The NM7 road and traffic flow - a safety issue

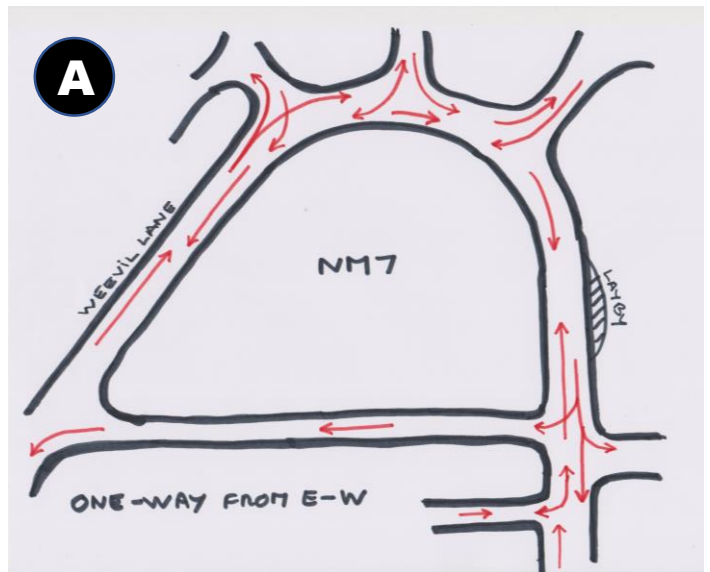
NM7 access road one way from the East as currently proposed adds to the complexity at the corner with two right turns close together.

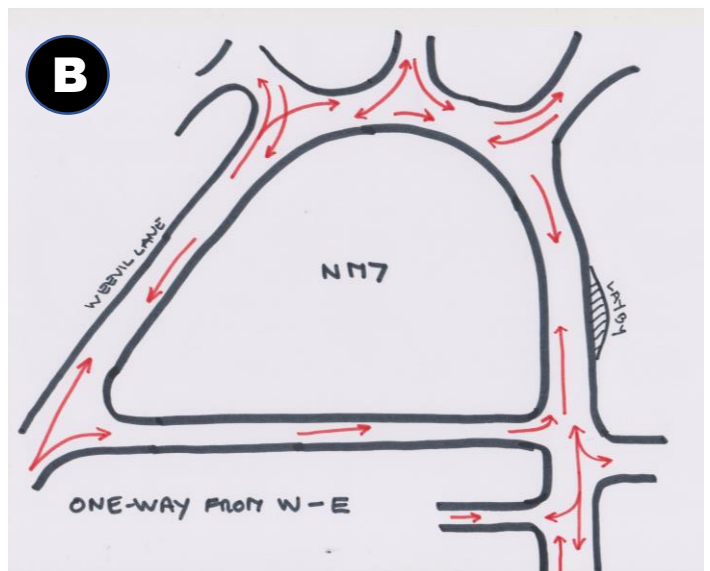
NM7 access road one way from the West reduces the traffic flow round the corner and enables a single directional sign to North Meadow .

Moving the North Meadow entry to the centre takes traffic clear of the dangerous corner and aids wayfinding.
